**MEMORANDUM**

REVIEW TYPE: Preliminary Plan Review

PROJECT NAME: Longwood

CASE #: 120060870

PRELIMINARY PLAN

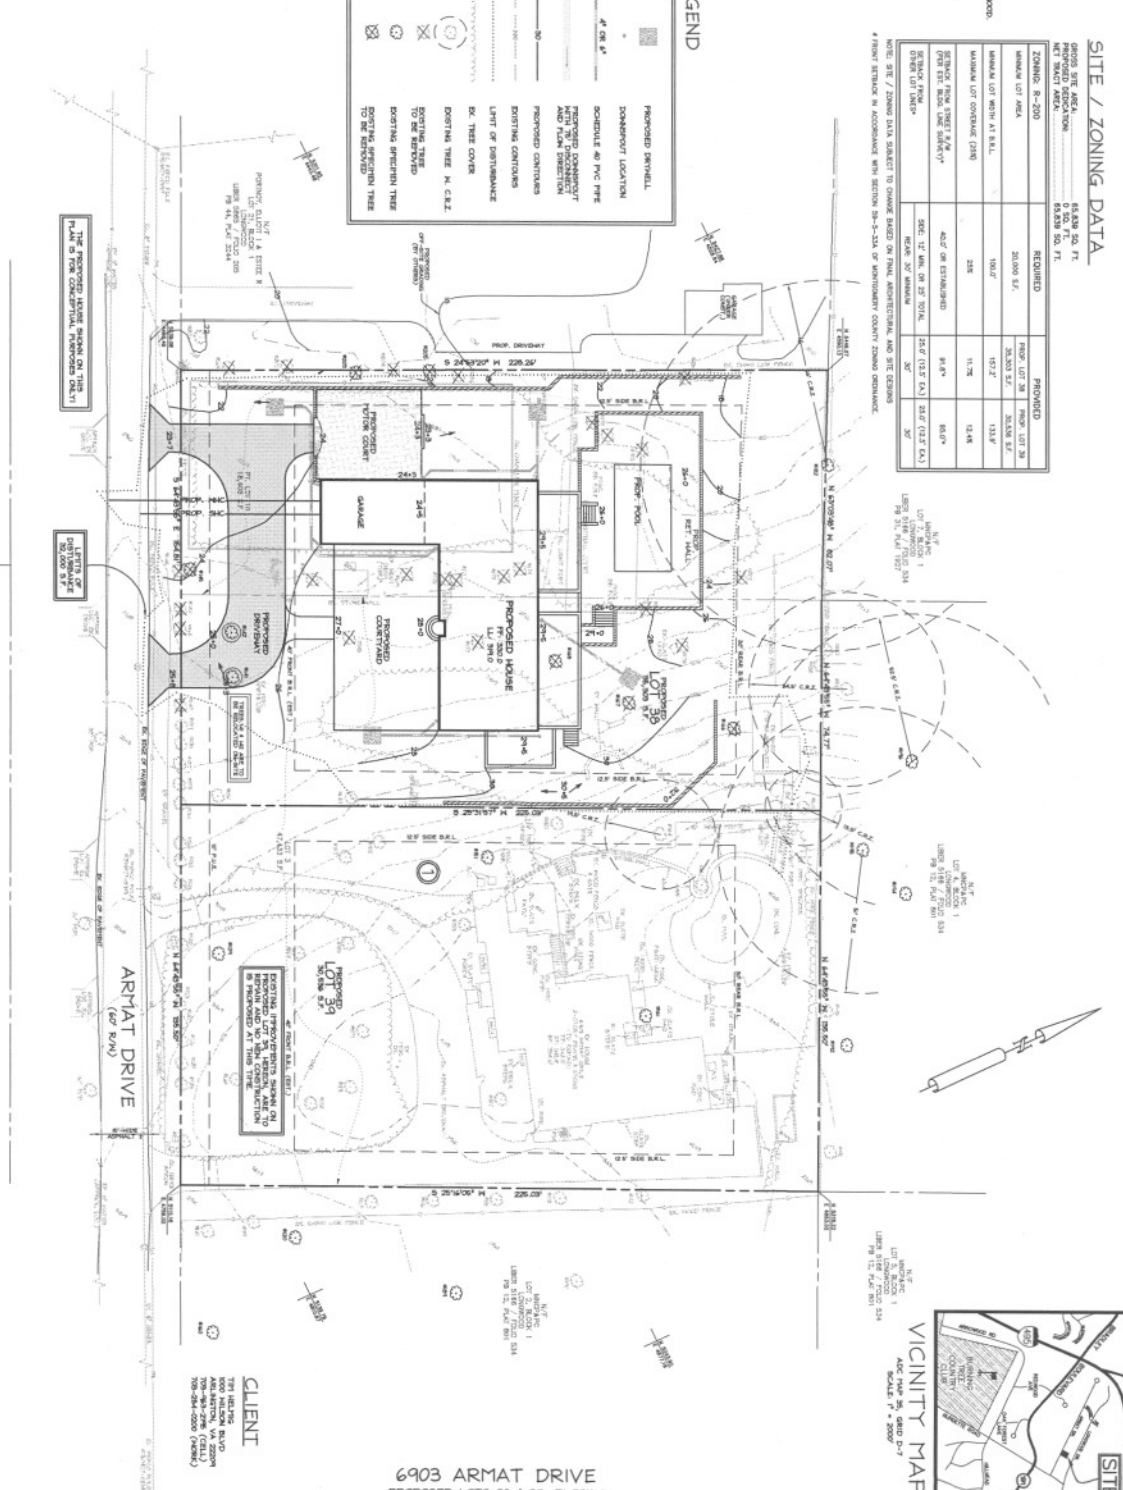
1. Show all existing driveways opposite the site on the preliminary plan.
2. Grant necessary slope and drainage easements. Slope easements are to be determined by study or set at the building restriction line.

4. Record plat to reflect a reciprocal ingress, egress easement for the portion of the existing driveway for proposed lot 39 that crosses adjacent lot 2.

DATE	BY	REVISION	PROJECT	DATE
5-03-06	JAK	REVISED PER D.R.C. COMMENTS	05-112B	03/2006
8-06-06	JAK	REVISED LOD	ILLUSTRATION	ENGINEERING
			CDS	CDS
			SCALE	APPROVAL
			1" = 20'	CAS
